# Sydney Metro West Westmead to The Bays and Sydney CBD

Amendment Report  
Concept and Stage 1  
2020

Figure 3-3: Proposed amendment to Kay Street and Unwin Street route and creek alignment works

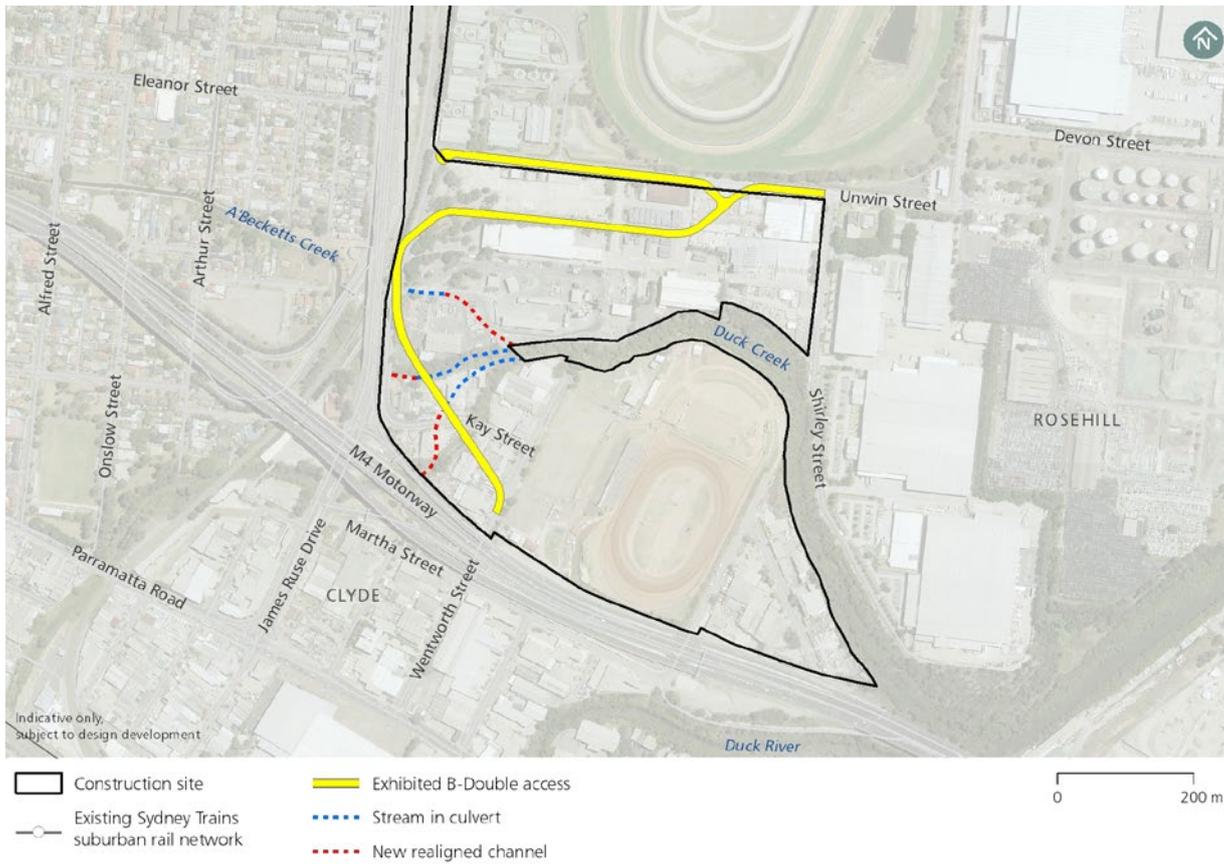
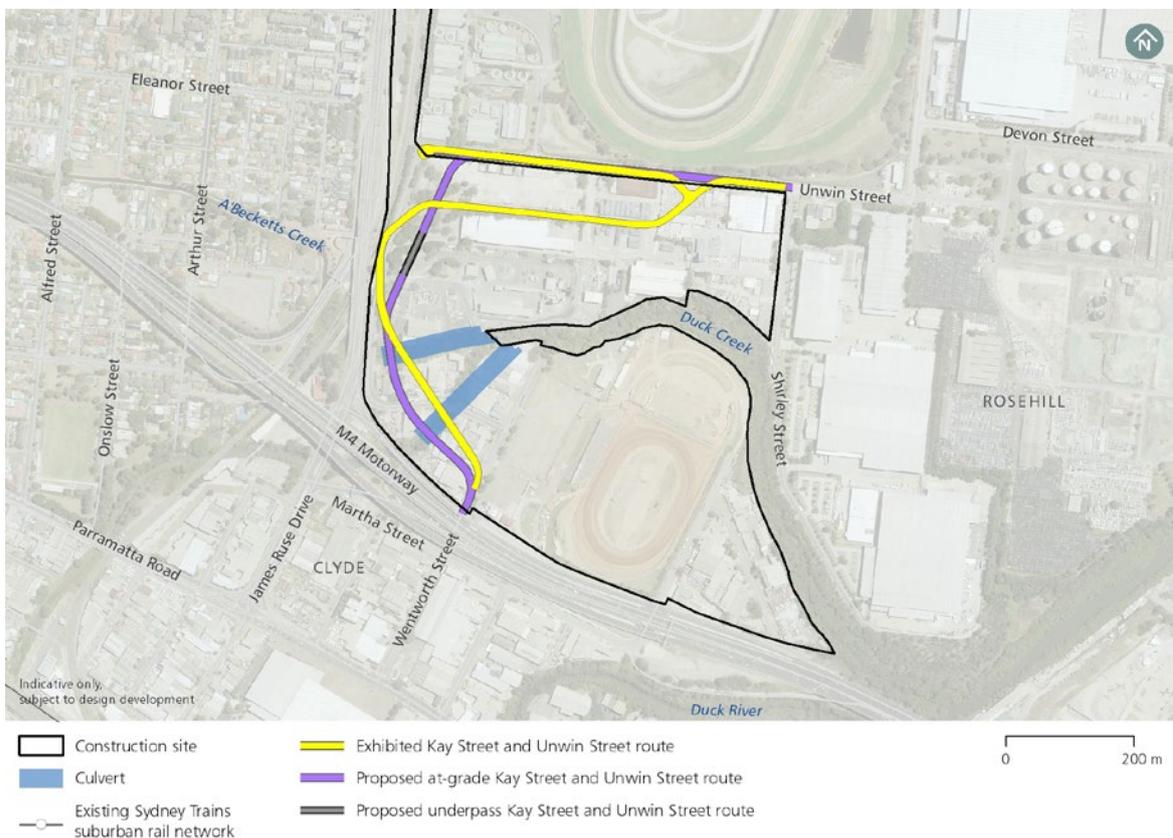
- **Change to the Kay Street and Unwin Street route** – the proposed road bridge over the future metro rail tracks would be changed to an at-grade road and a road underpass designed to accommodate B-double trucks (refer to Figure 3-3). The underpass section would have a length of about 80 metres, a sign posted clearance of 4.6 metres, and a shared path to accommodate pedestrians and cyclists on one side.

- **Change to the culverts** – the revised at-grade route would require the refinement of the creek realignment and culverts. This is shown on Figure 3-3 and includes:

Figure 3-8: Potential change in flood hazard - one per cent AEP event for the proposed amendment compared to existing environment

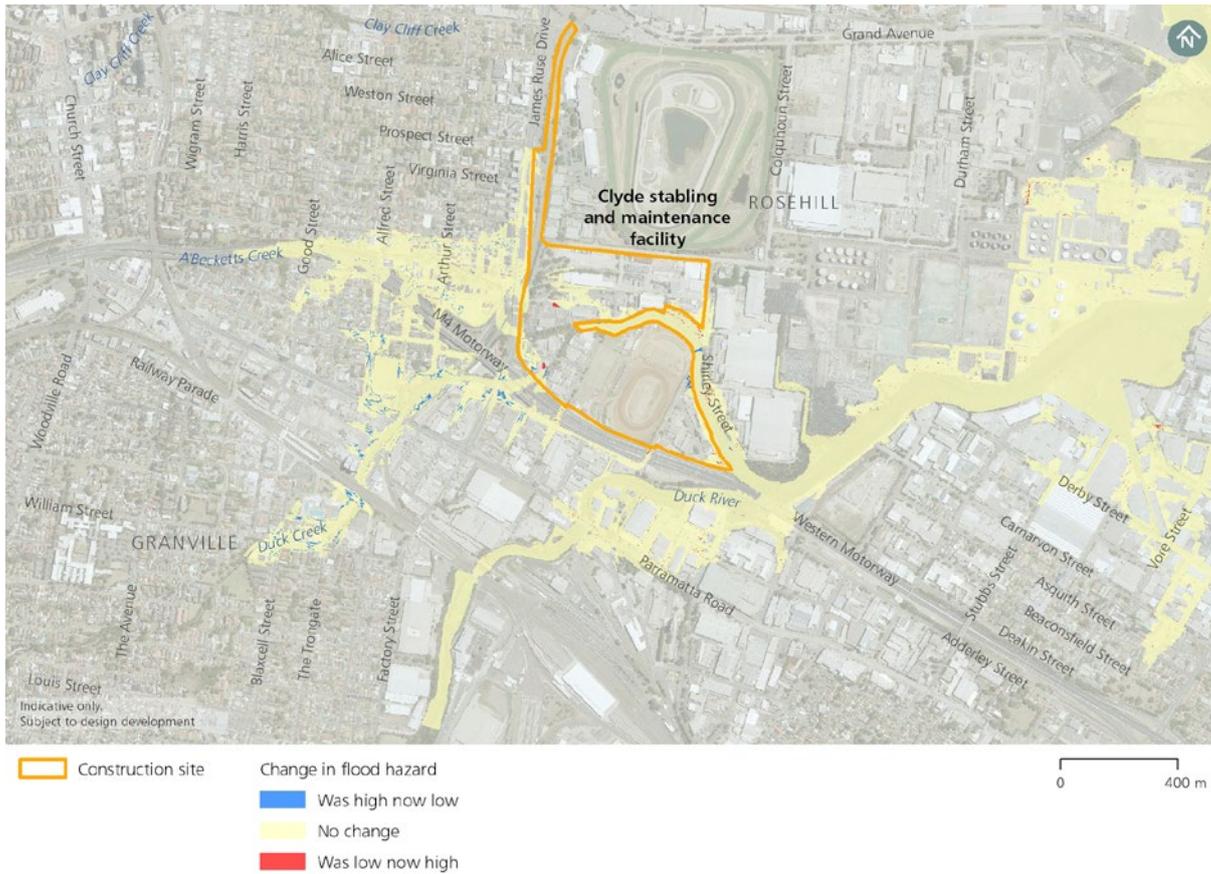
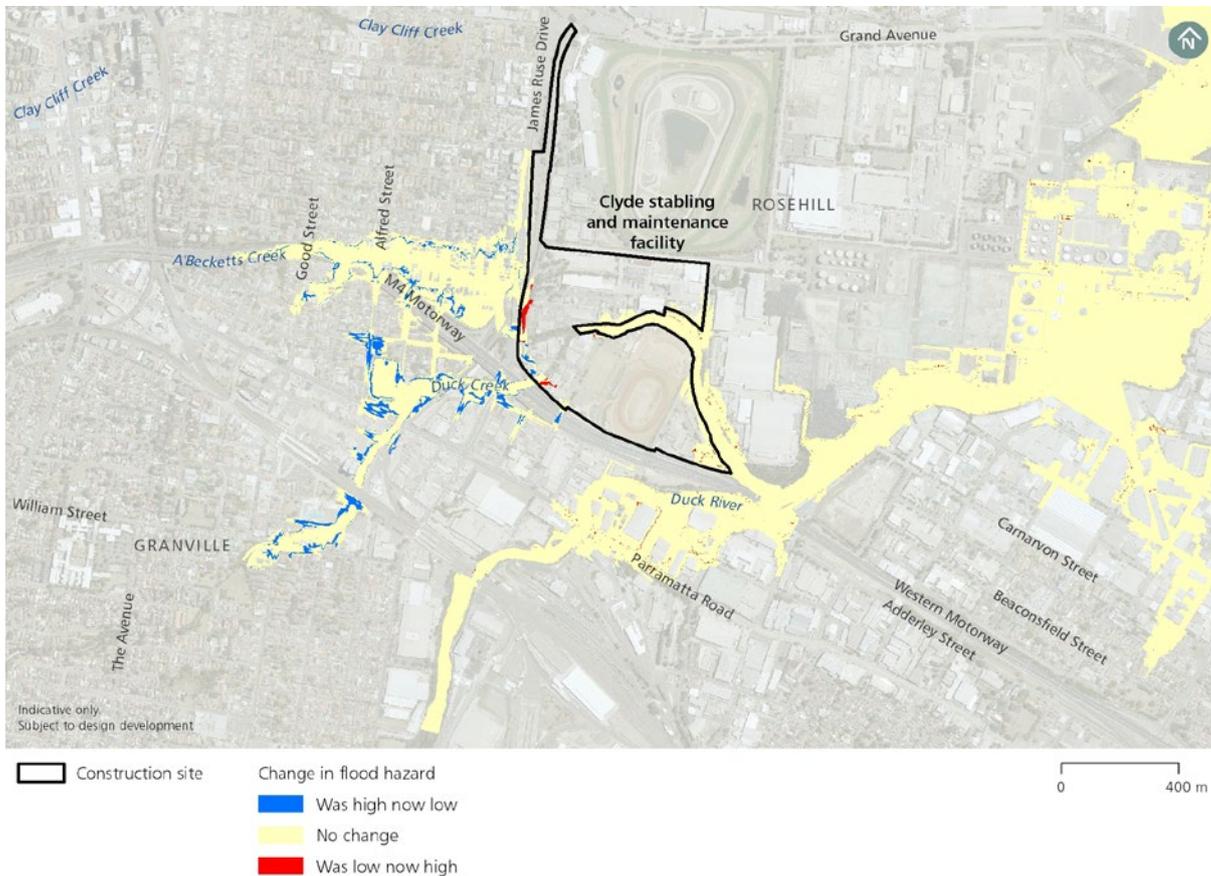
Potential maximum increases in the PMF extent of around 10 metres and typical increases of less than five metres.	Potential maximum increases in the PMF extent of around 10 metres and typical increases of less than five metres.	
<b>Change in flood hazard</b>	Potential minor increases in the high flood hazard extent in the five per cent and one per cent AEP and PMF events (refer to Figure 21-1 to Figure 21-3 of the Environmental Impact Statement).	Potential minor increases in the high flood hazard extent in the one per cent AEP (see Figure 3-8) and PMF events (see Figure 3-10).	No change compared to the Environmental Impact Statement. See Figure 3-7 and Figure 3-9 for the potential change in flood hazard predicted in the Environmental Impact Statement, for comparison.
	Some potential reductions in the high hazard extent in the five per cent and one per cent AEP events (refer to Figure 21-1 and Figure 21-2 of the Environmental Impact Statement).	Some potential reductions in the high hazard extent on the Duck Creek and A'Becketts Creek floodplains upstream of the Clyde stabling and maintenance facility in the one per cent AEP event (see Figure 3-8).

Figure 4-2: Amended Sydney Olympic Park metro station indicative construction site layout

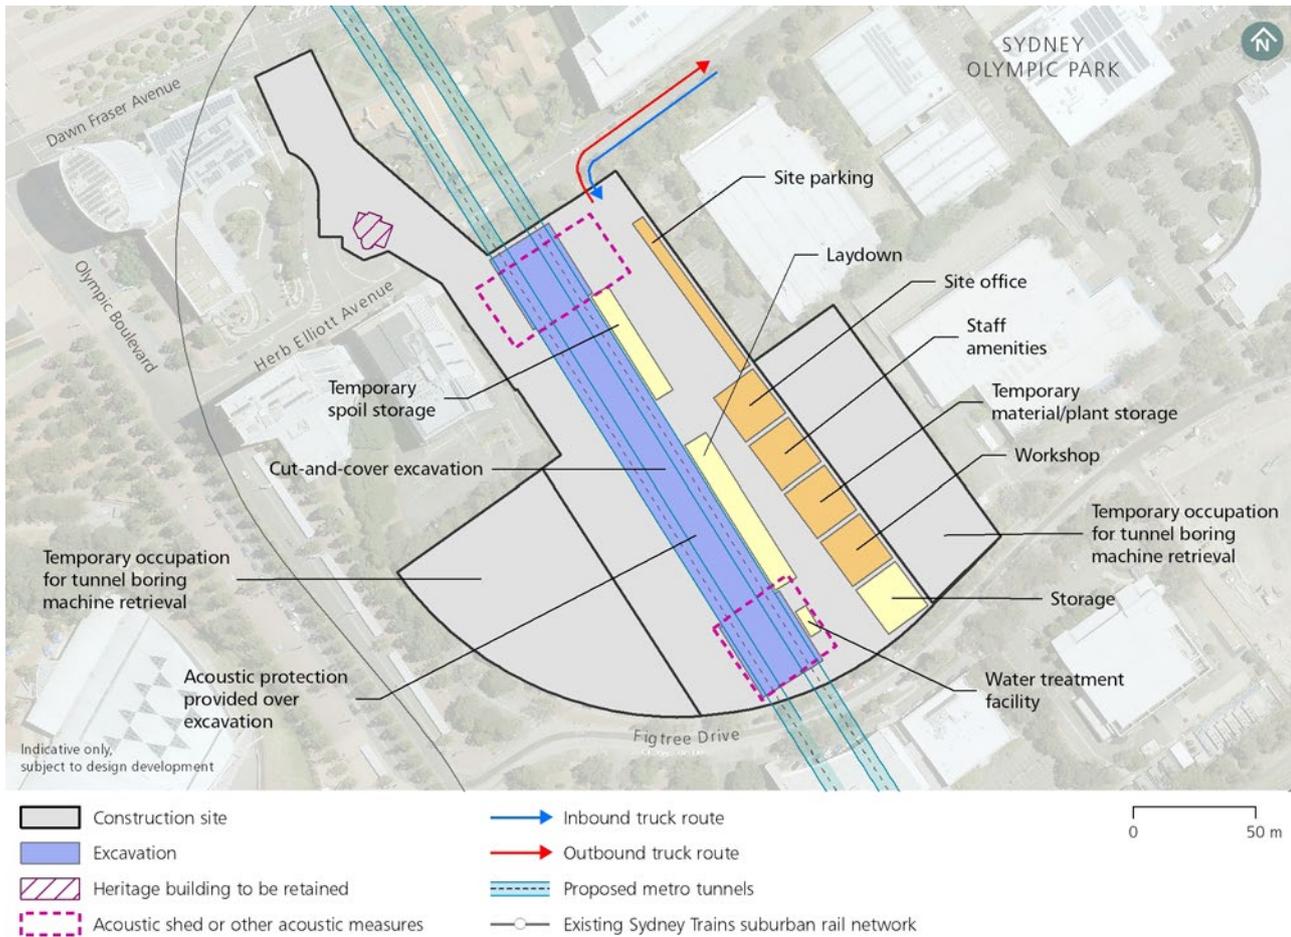
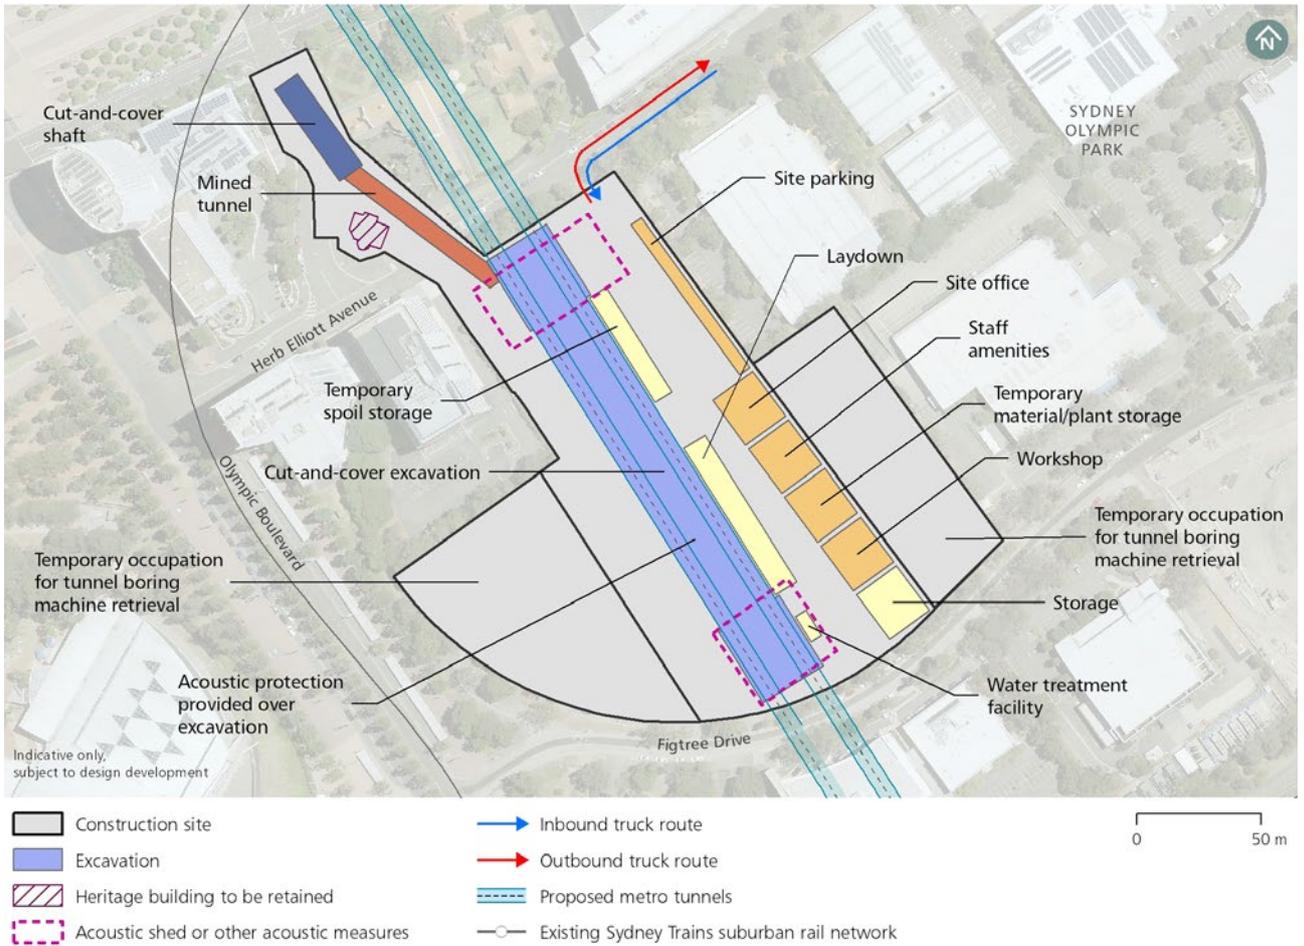
It is proposed to change the construction methodology for the northern pedestrian entry from cut-and-cover to a mined tunnel with a cut-and-cover shaft at the northern end to join Dawn Fraser Avenue. This would connect the secondary pedestrian entry to the main station. This is shown in Figure 4-2. The mined tunnel would be about 17.5 metres deep from ground level to floor level.

Figure 5-2: Amended road network modification at Five Dock Station construction site

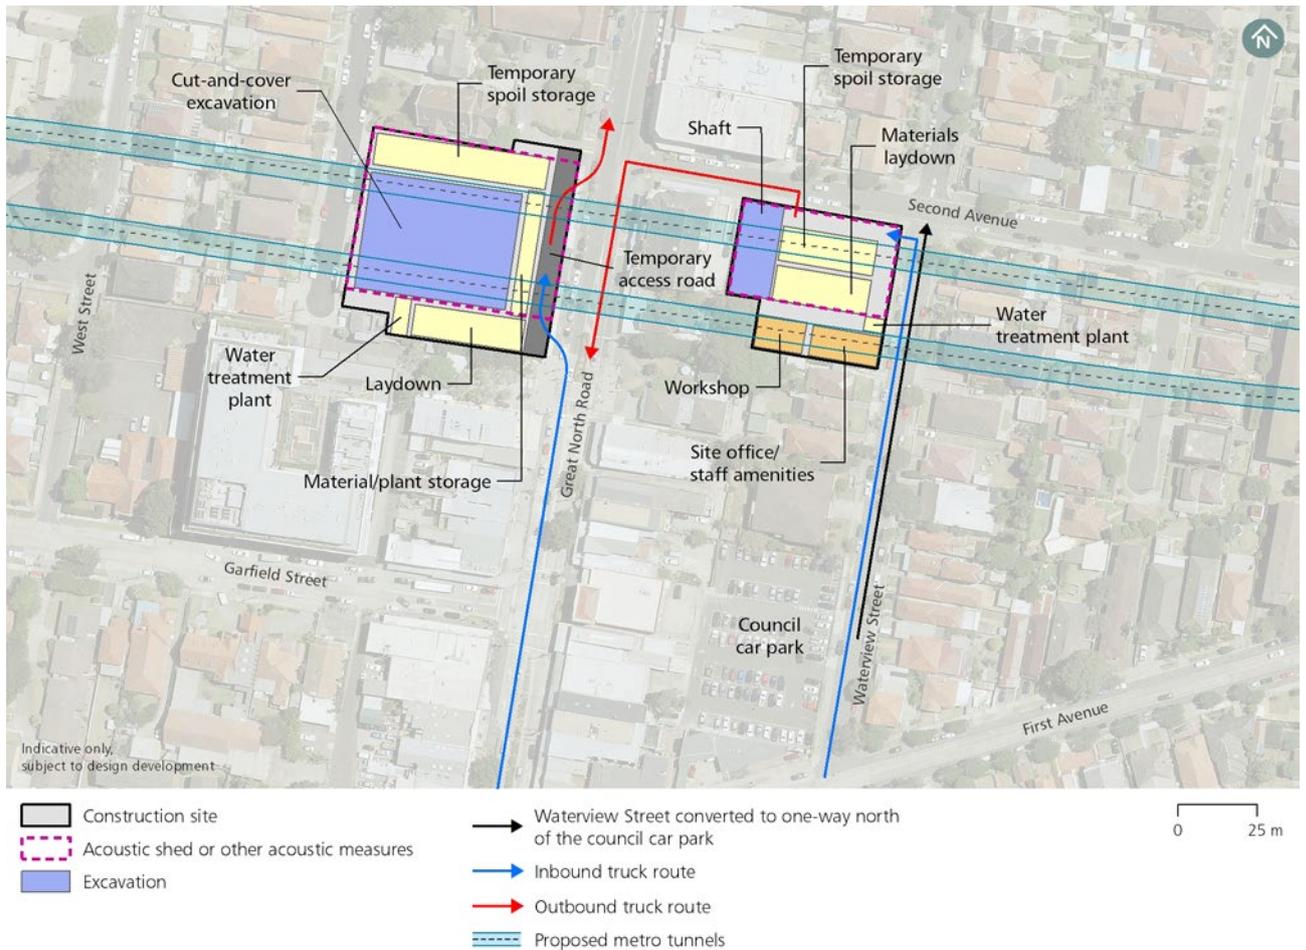
It is proposed to convert Waterview Street from a two-way street to a northbound one-way street north of the main Five Dock car park up to Second Avenue, for the period of Stage 1 construction. This is shown in Figure 5-2. Southbound traffic would be redistributed to other local streets.

Figure 6-2: Amended The Bays Station indicative construction site layout

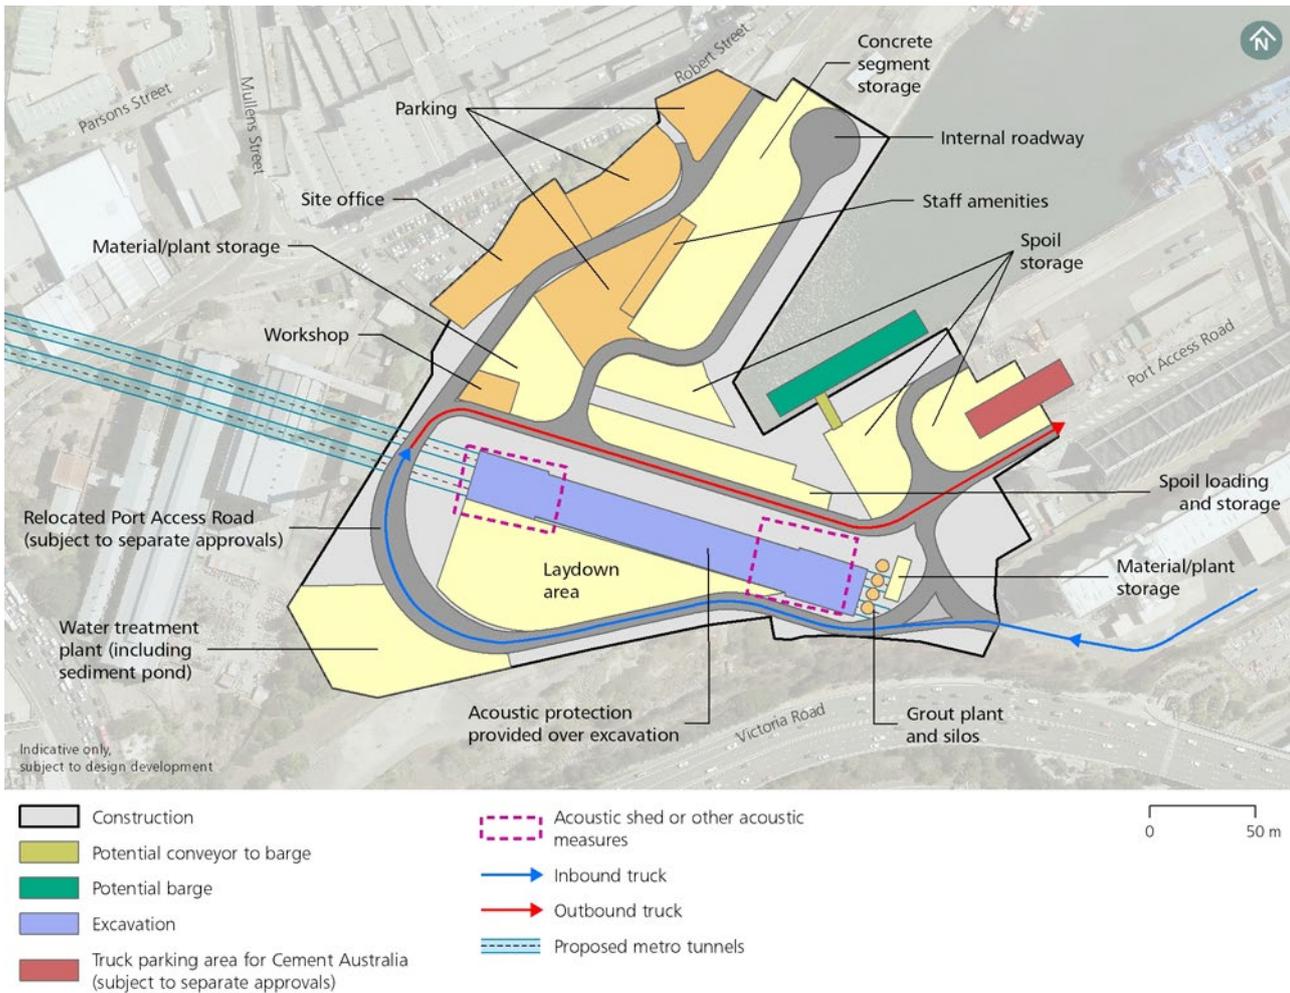
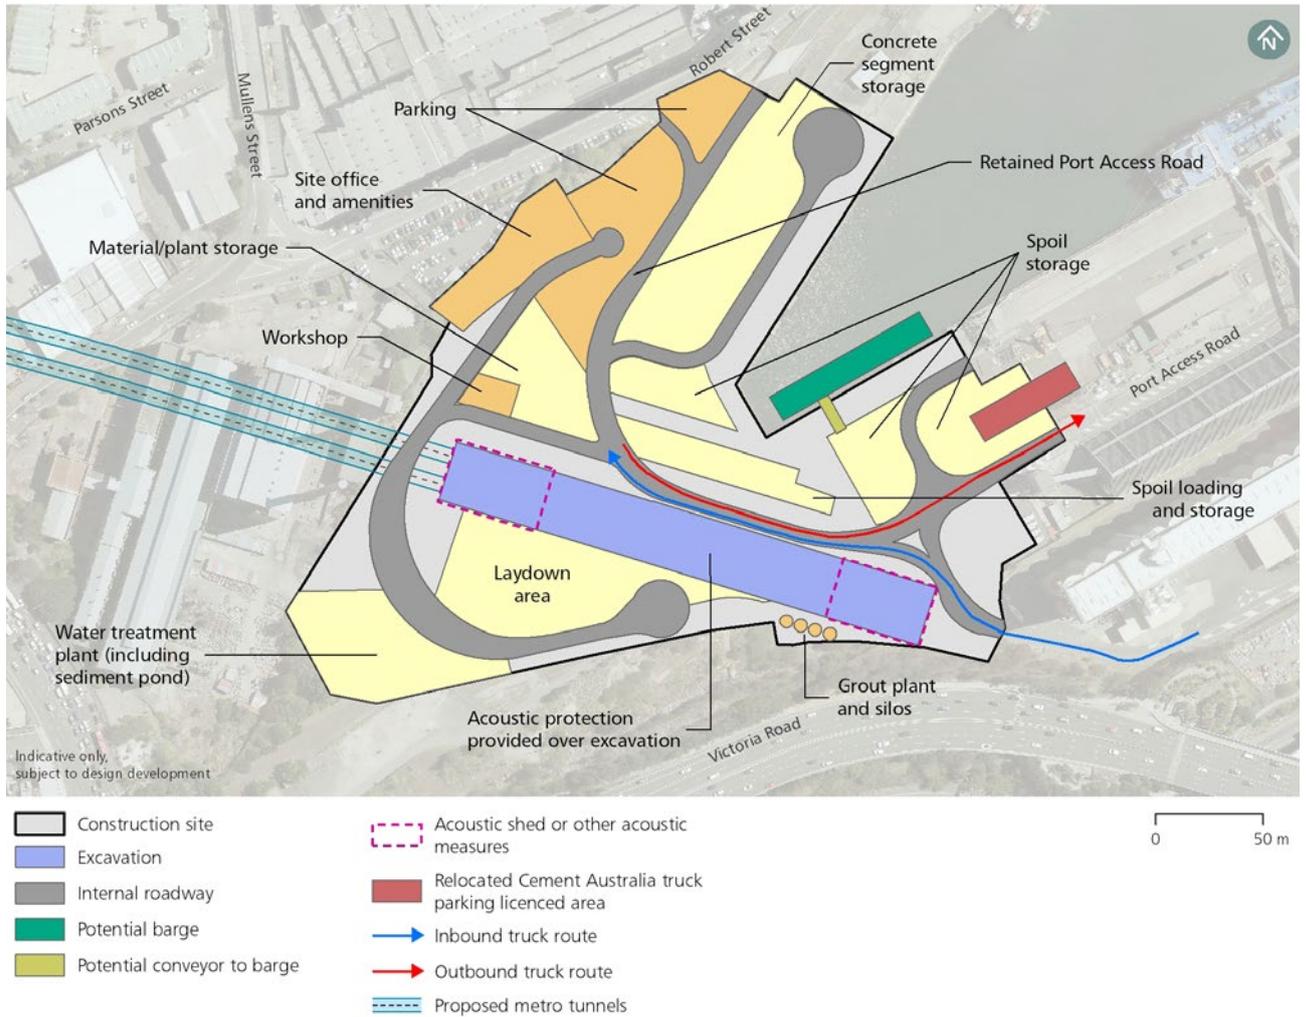
The proposed amendments to the construction site layout are shown in Figure 6-2 and include:

- Adjustment of staff amenities, storage areas, and sheds around the retained Port Access Road and longer station box
- Repositioning of the acoustic sheds (or other acoustic measures) to avoid the retained Port Access Road and reflect the longer station box
- Relocation of the grout plant and silos to the southern side of the station box.
